STAFF RECOMMENDATION
1712 Blair Boulevard
March 17, 2021

Application: New Construction—Outbuilding
District: Belmont-Hillsboro Neighborhood Conservation Zoning Overlay
Council District: 18
Base Zoning: RM20
Map and Parcel Number: 10416004300
Applicant: Will Jenner
Project Lead: Melissa Sajid, melissa.sajid@nashville.gov

Description of Project: Application is to construct an outbuilding that is less than twenty feet (20') from the addition approved in December 2020.

SITE PLAN

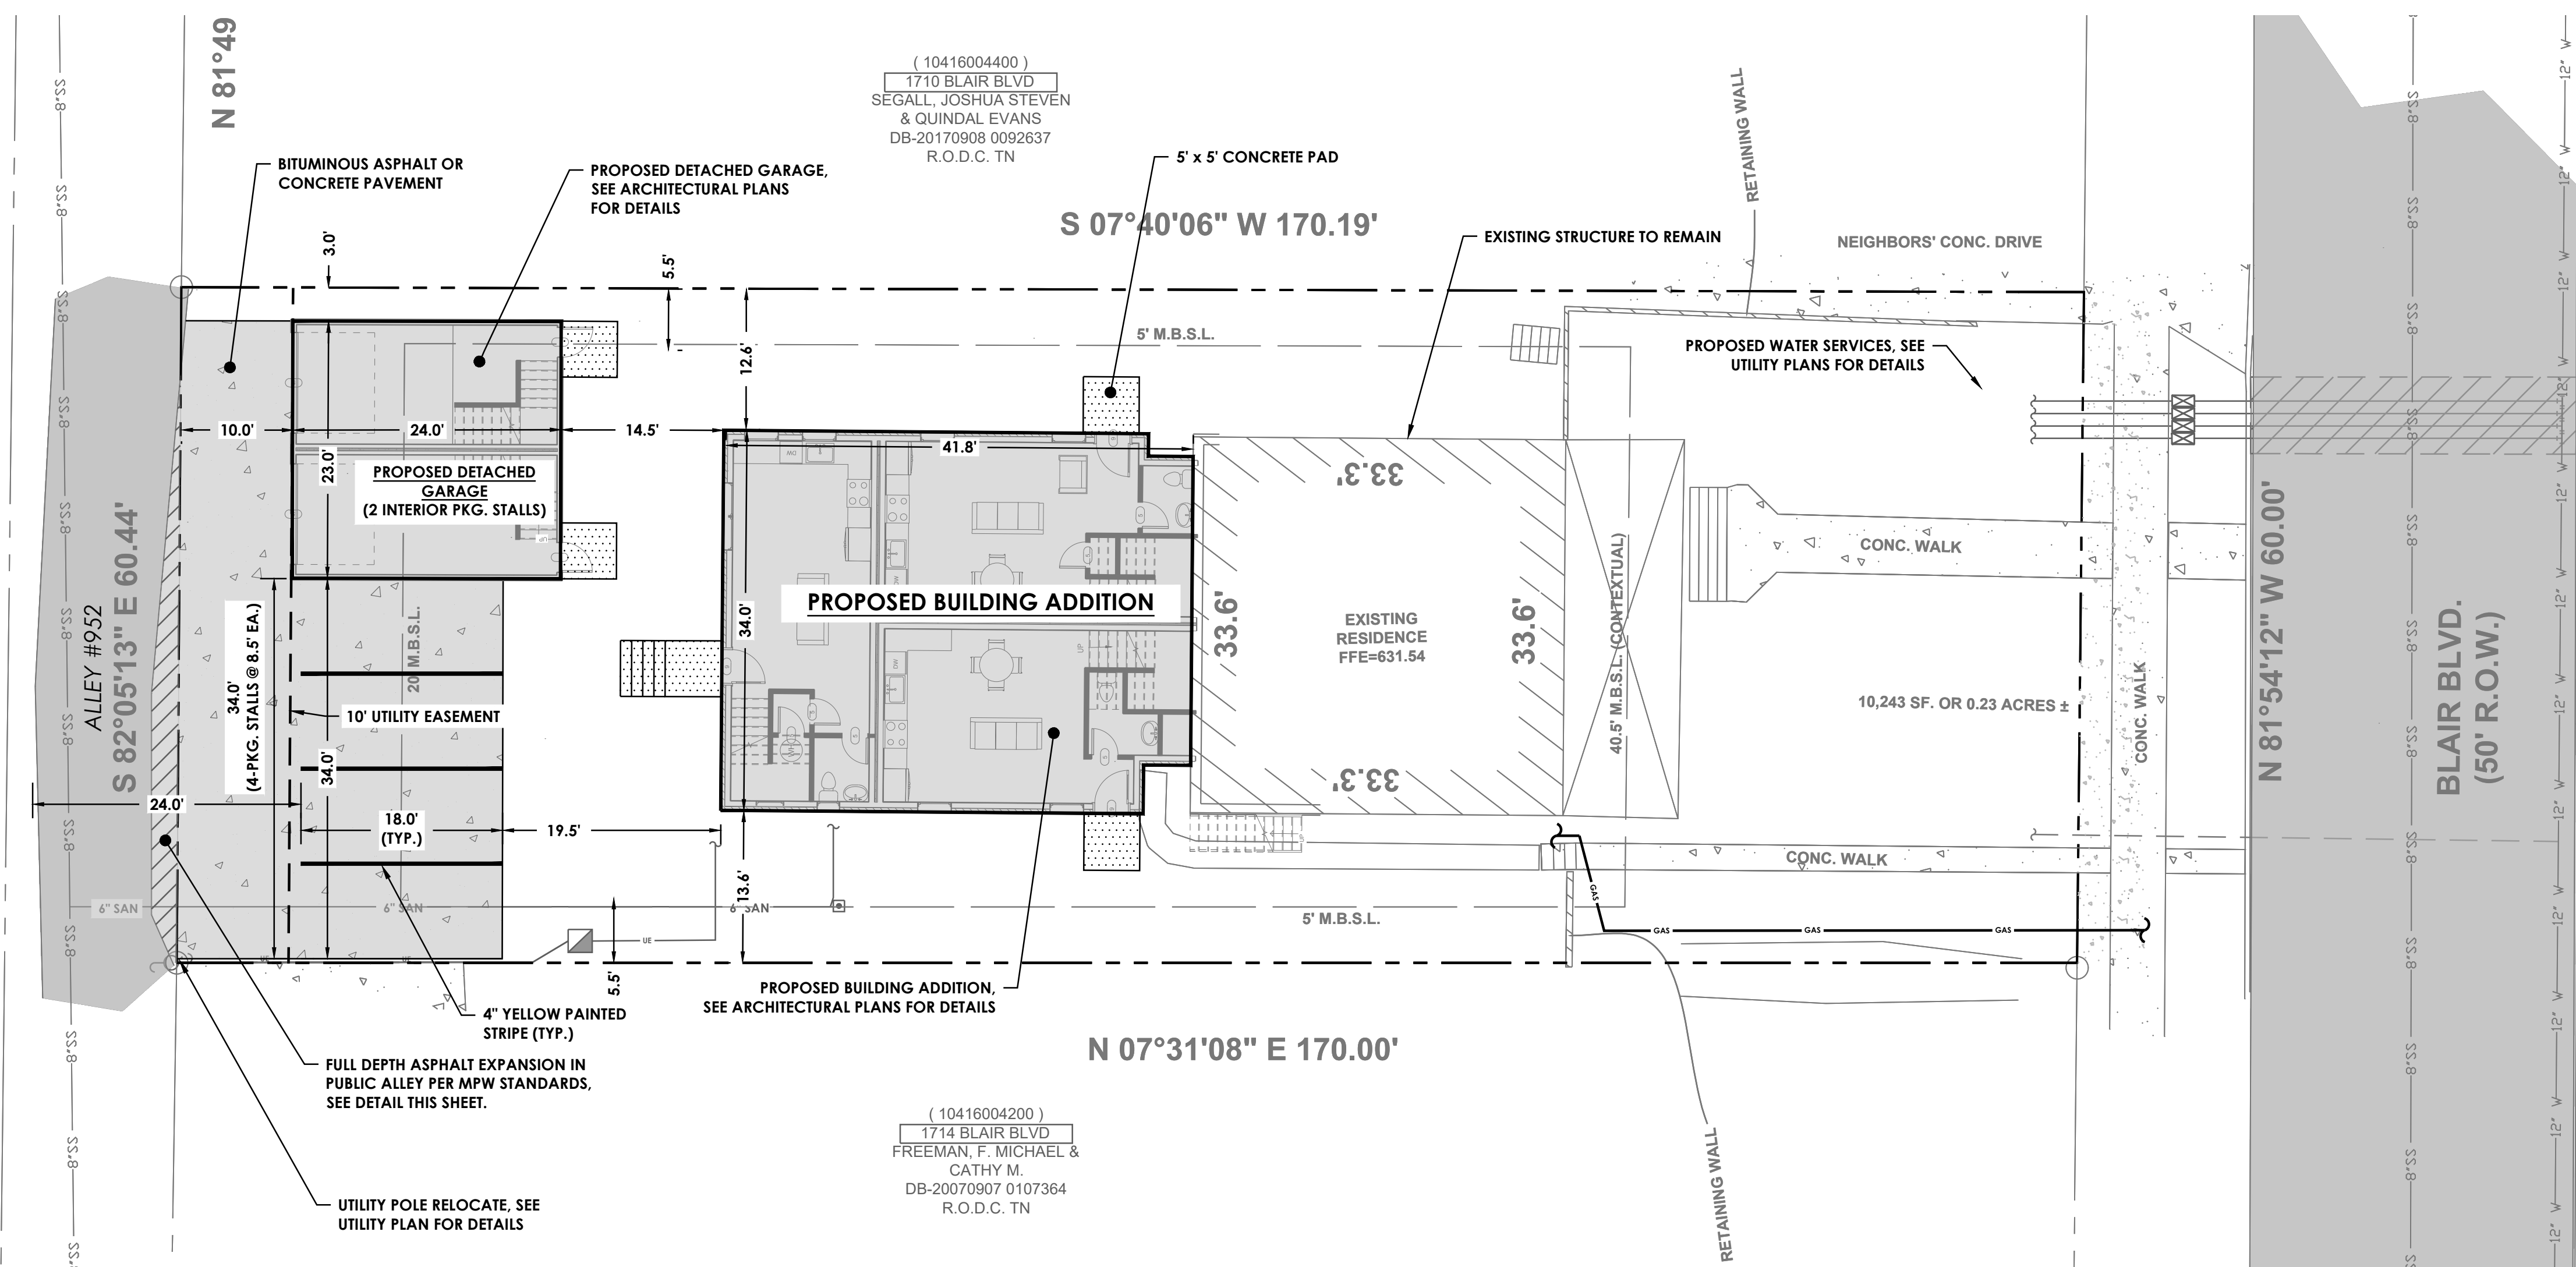
MINIMUM	PROPOSED OUTBUILDING
Building located towards rear of lot	-	Yes
Space between principal building and garage	20'	14'-6" *
Rear setback – garage doors face alley	5'	10'
Right-side Property Line	3'	3'
Left-side setback	3'	34'
How is the building accessed?	-	From alley
Two different doors rather than one large door (if street facing)?	-	N/A

*The outbuilding meets all base zoning setbacks but is located only fourteen feet, six inches (14'-6") from the rear of the addition that was approved in December 2020. The design guidelines require that outbuildings be located at least twenty feet (20') from the rear of the primary structure. The project involves the relocation of an NES pole along the rear property line and includes a ten foot (10') wide easement at the rear of the property. Given the location of the utility easement as well as the small footprint of the outbuilding, staff finds that the proposed location of the outbuilding can be appropriate in this case.

With the condition that staff review the final selections of all materials prior to purchase and installation, staff finds that the outbuilding's height, scale, roof form, materials, location, and setbacks can meet Section II.B.1.i. of the design guidelines.
